**Re: Proposed Amendments to Land Use Bylaw 1P2007  
PUD2019-0402**

Subject: PUD2019-0402

A proposal to PUD2019-0402 amendments.

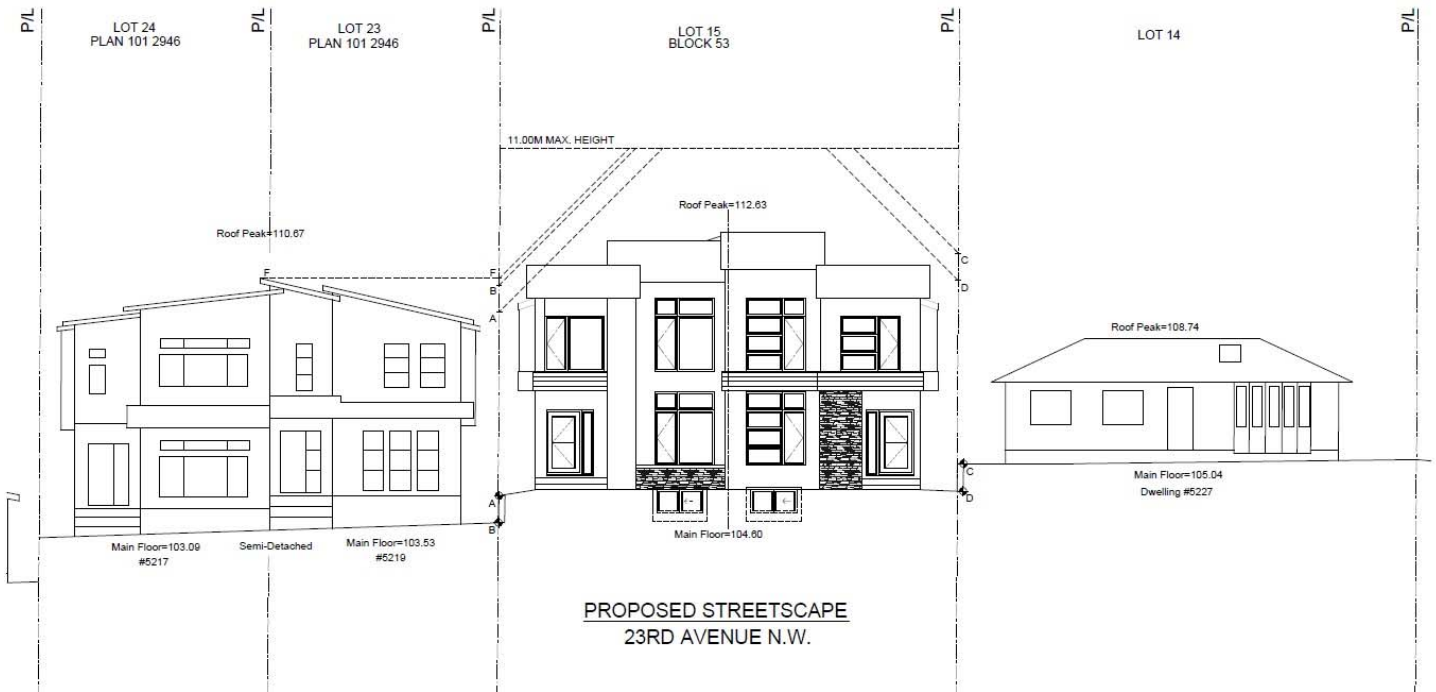
Grade is not defined enough: is ground surface at house? Property line? Corners of lot or at house. If it is at the house, it raises the question about what is an artificial embankment and what is allowed for building up the final grade. The following illustrations are for purposes of grade determination only. More will follow on the many other lines shown.

Here is an example of an approved DP. In this scenario where would we measure grade under the new amendments? As you can see this impacts greatly what is allowed based on this type of architectural form. Almost every case fails.

**69 Grade for determining building height**

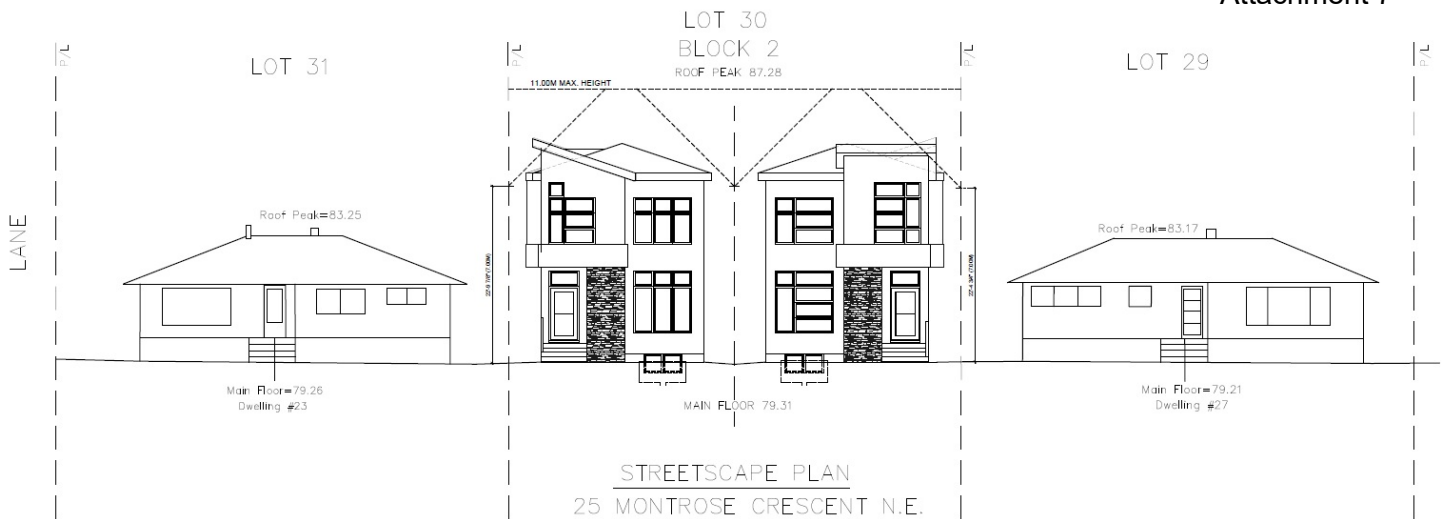
This DP on 23<sup>rd</sup> ave has similar architecture but again grades and retaining walls make it challenging to determine where you measure for grade.

Perhaps something along the following wording could be adopted?

The elevation of the finished ground surface as shown from subject parcel property grades, to the finished grade at foundation, not exceeding a 4% slope. This could include any artificial embankment not exceeding more than a 4%, and not the elevation of an entrance to underground parking, stairways or window wells.

4% is an allowable slope for drainage in all directions and identifies grades at foundation for purposes of measuring height. If the parcel warrants higher than 4% for other factors, that is still permissible, *but not for determination of height*. This stops falsifying grades to achieve height outcomes. *(up to 8% could be an allowable range as well)*

Figure 5: Proposed height chamfer next to a building over 7 metres

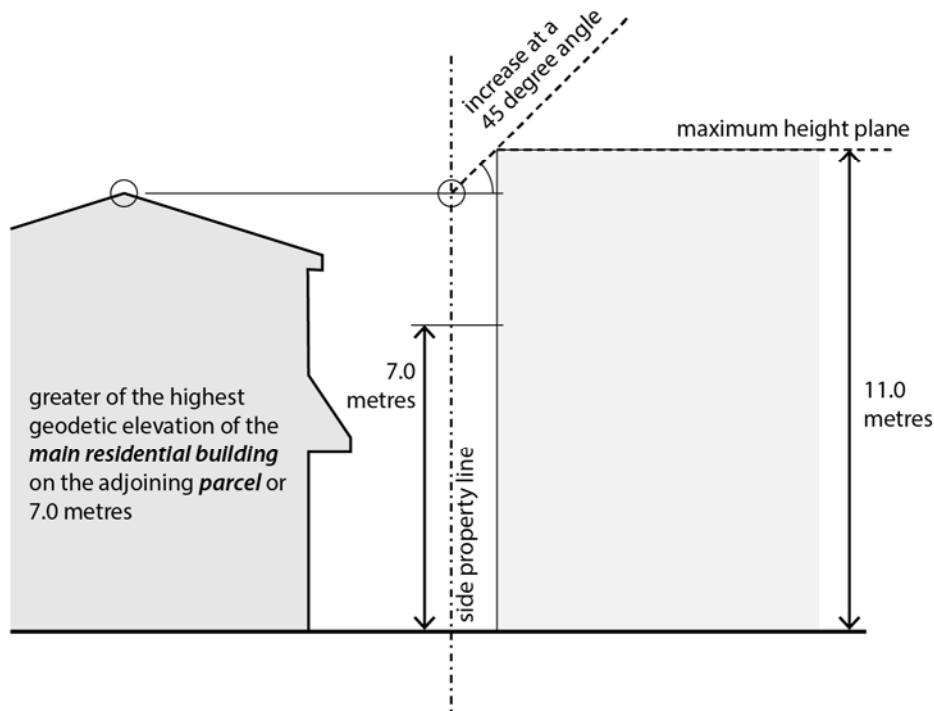
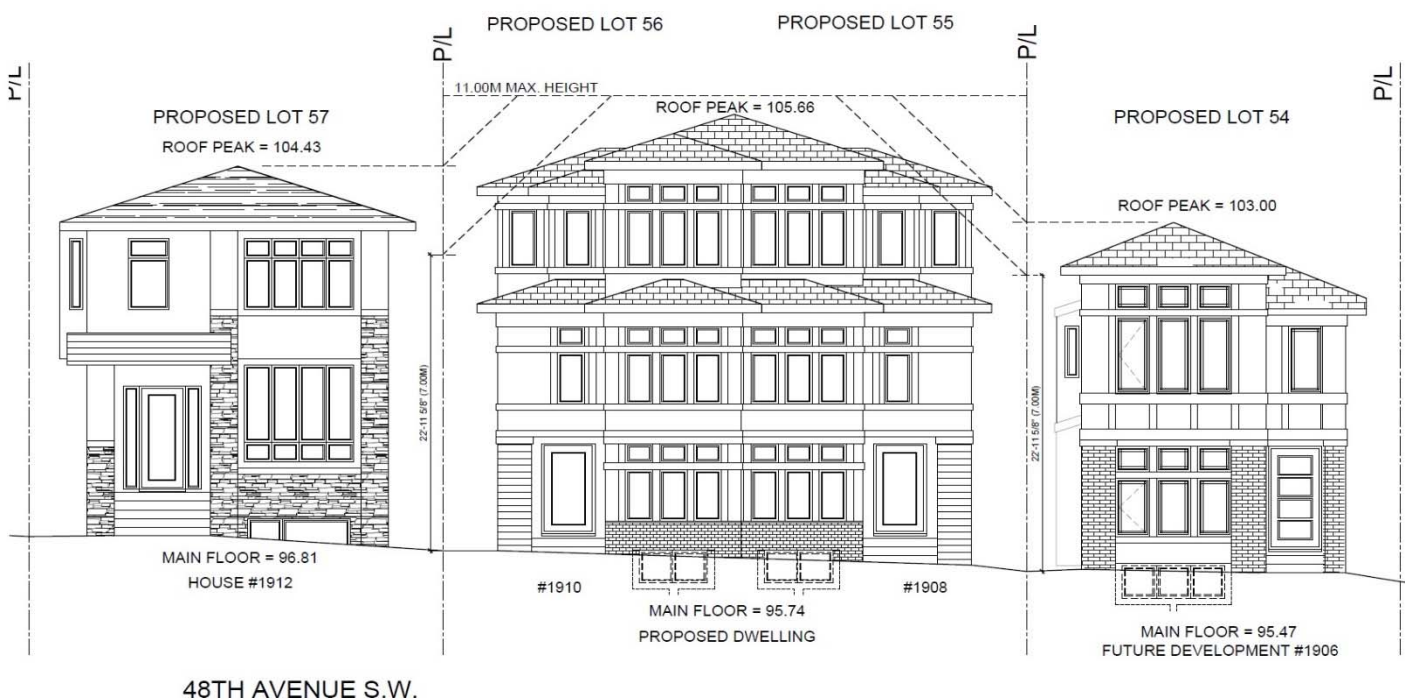
On the following example, we using the roof peak from the adjacent building, not staying with the contextual height of the both sides. This makes a difference as shown in the following example. The contextual height would be higher on the right side and lower on the left and not the same as roof peaks in this case. This needs better clarification.

Figure 4: Proposed height chamfer next to a building under 7 metres

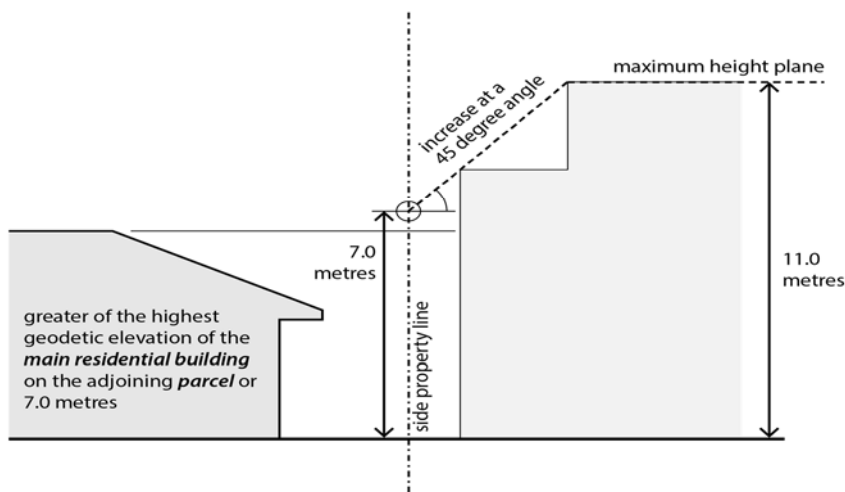
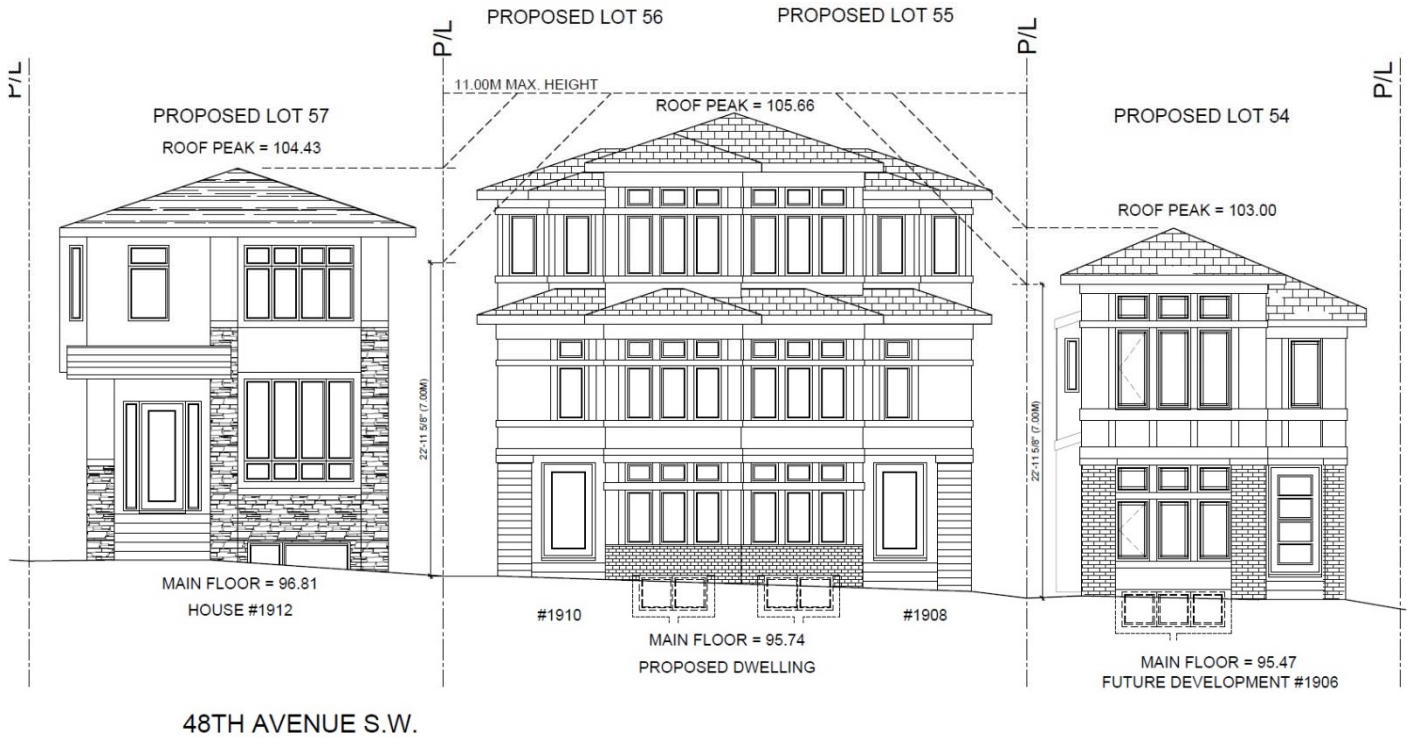
The following example, also shown above, and under the proposed amendment, gives a much more limited space a 3 storey type of build form. We have illustrated a second set of lines showing where a bungalow on either side would fail this building. So while this amendment is good for existing conditions with two storeys, it does not provide for a “final outcome” result with bungalows.

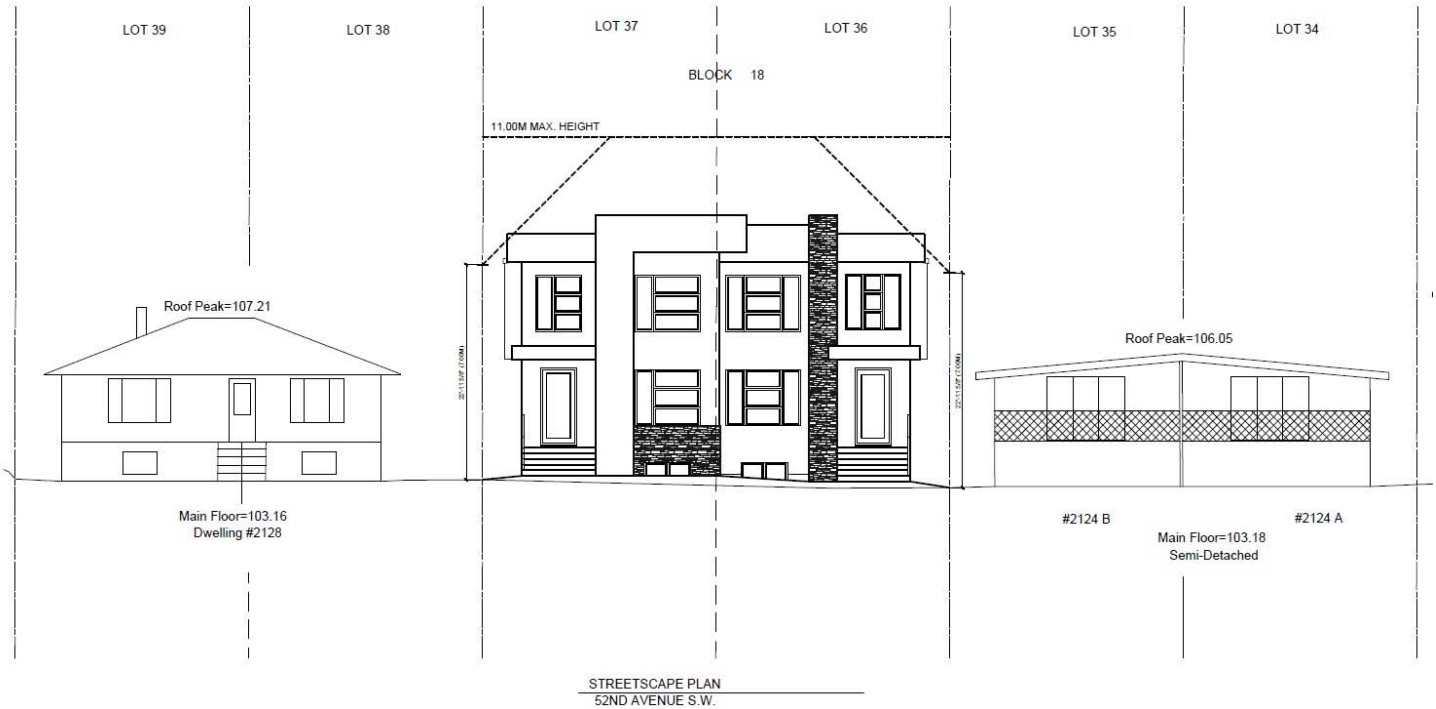
And this architectural style fails as a 2 storey under the same scenario.

STREETSCAPE PLAN  
21ST AVENUE N.W.

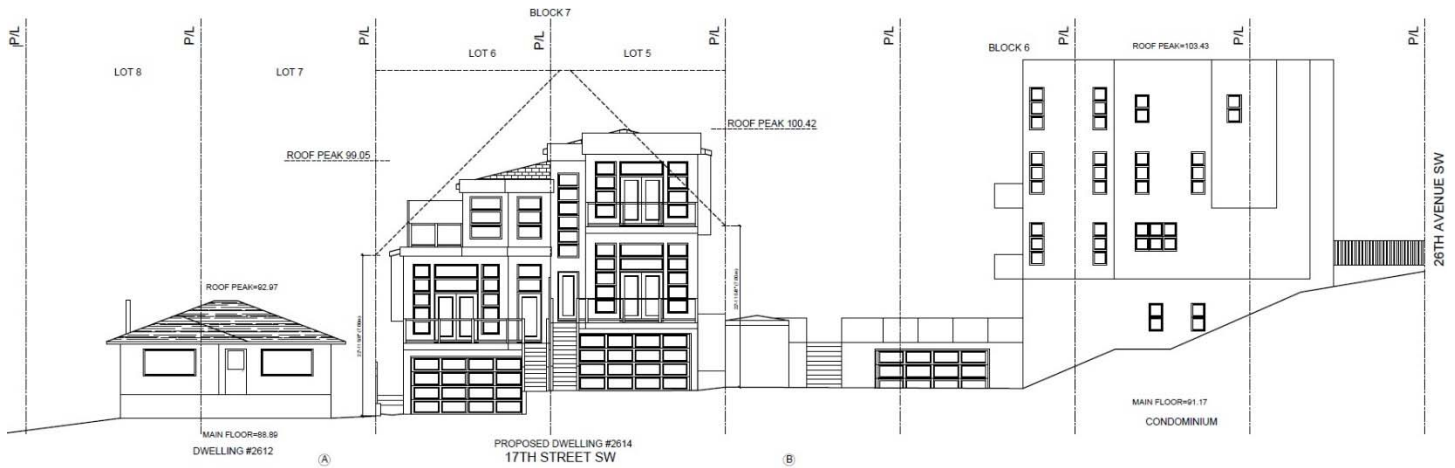
This example below is how the “final outcome” could look like but because of the bungalows, the subject lot lower in height. But the neighbouring lots could now be built to potential as shown in dotted lines. This will create an uneven and disjointed streetscape at “final outcome”.

Figure 4: Proposed height chamfer next to a building under 7 metres

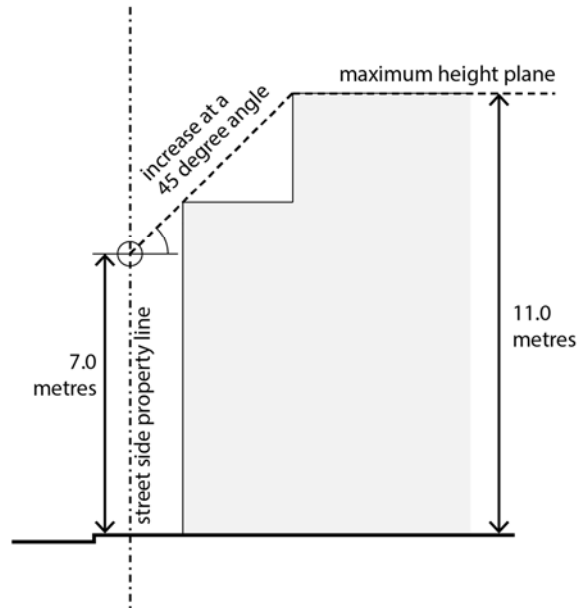
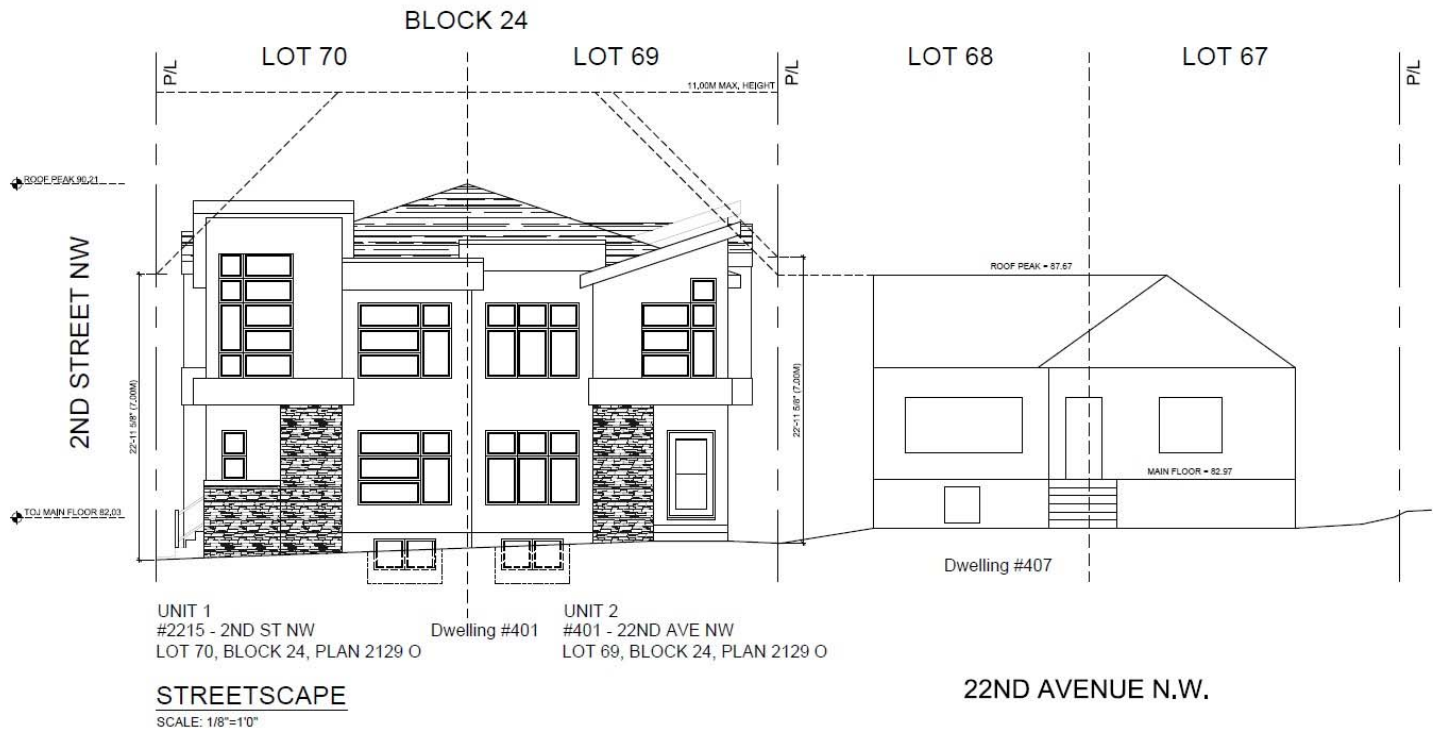
In 90% of the examples we tested, every single design that had any modern architectural features on the side **failed**. Every 3 storey design **failed** miserably.

If you take many of the above examples and put them on corner lots, they **fail** as well.

This example above is built and occupied on a corner lot, but **fails** under proposed amendments.

Figure 2: Method for measuring the height of a single or semi-detached dwelling on a sloping site in the low density residential districts

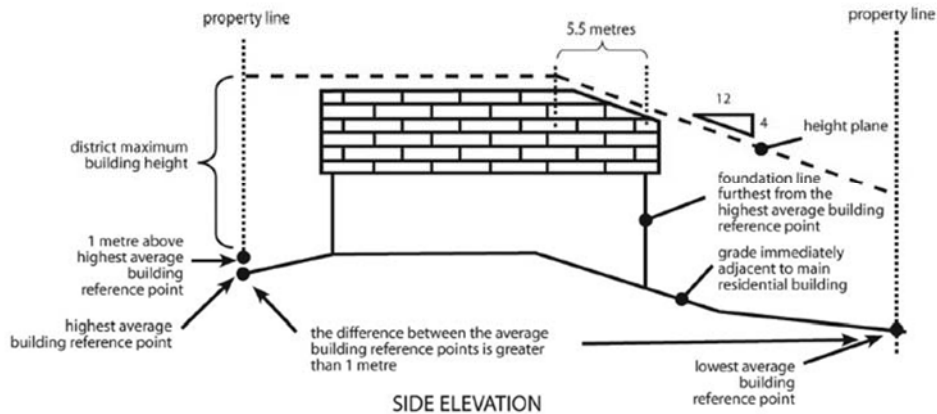
The above amendment illustrations require updating and clarification.

While front and back property lines are not indicated, the illustrations portray the rear to be to the right and the front to be on the left. The issue with the is that the scenario can be found in both cases, not just the rear. Many front walk outs share the same chamfer rule so some clean up would be a good idea. The illustrations also depict 1 meter above grade the district maximum.

Figure 1: Method for measuring the height of a single or semi-detached dwelling on a flat site in the low density residential districts

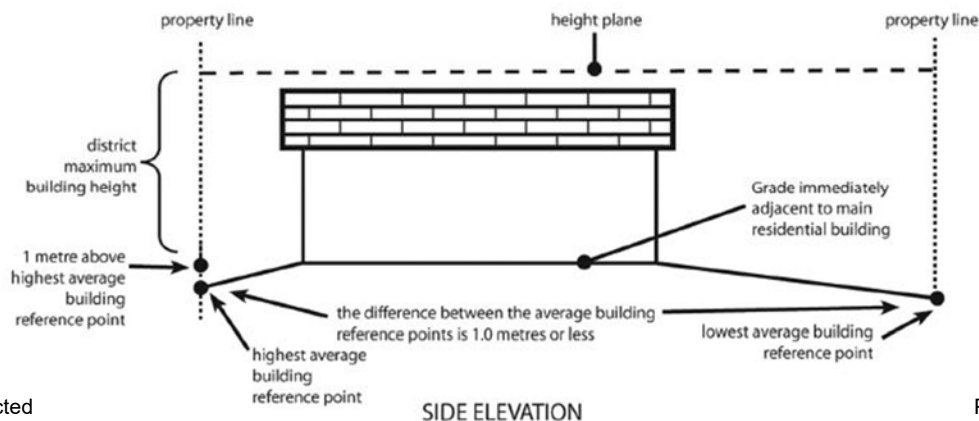
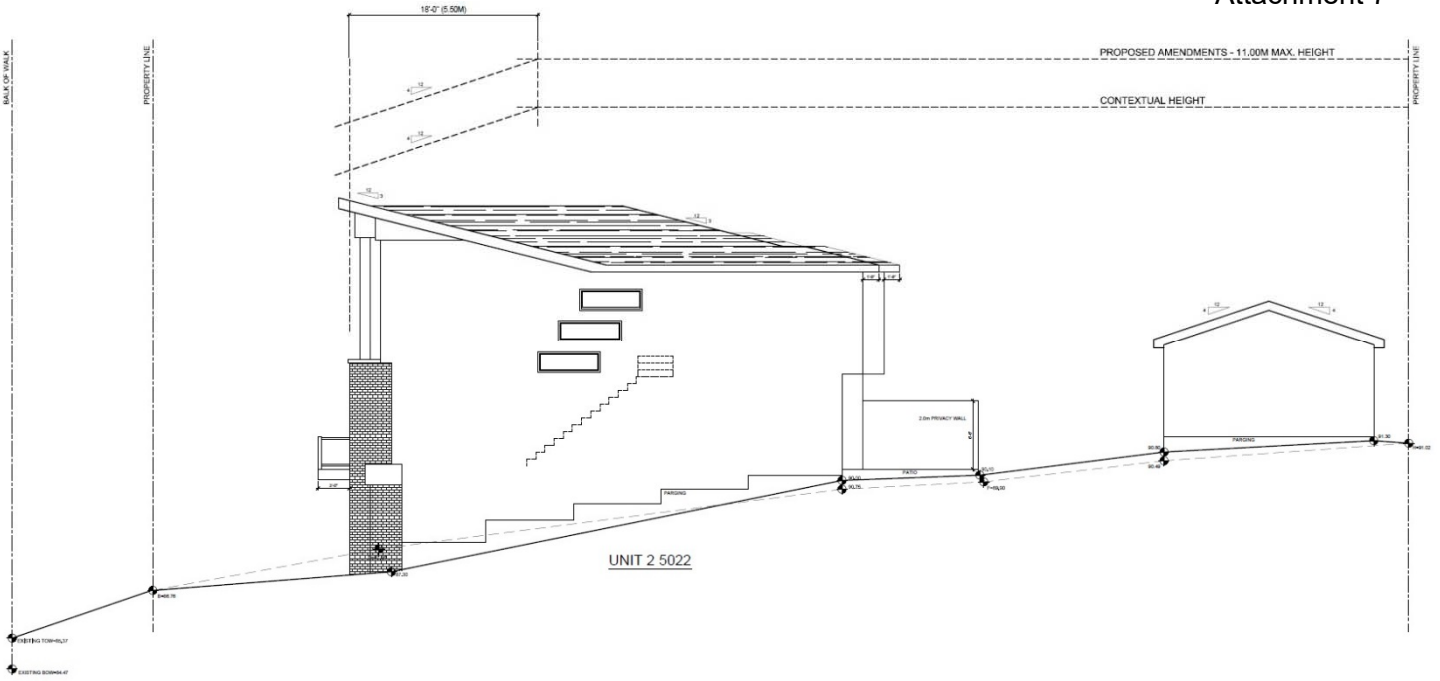
Here is an example of an approved DP. Under these rules, you cannot build above the lower line. This also depicts a slope to the rear lane.

If the 11m is to be used, with or without a chamfer, there is a lot of room to create exciting rear exteriors, but lots and lots of massing. Was this the intent of this amendment or am I missing something?
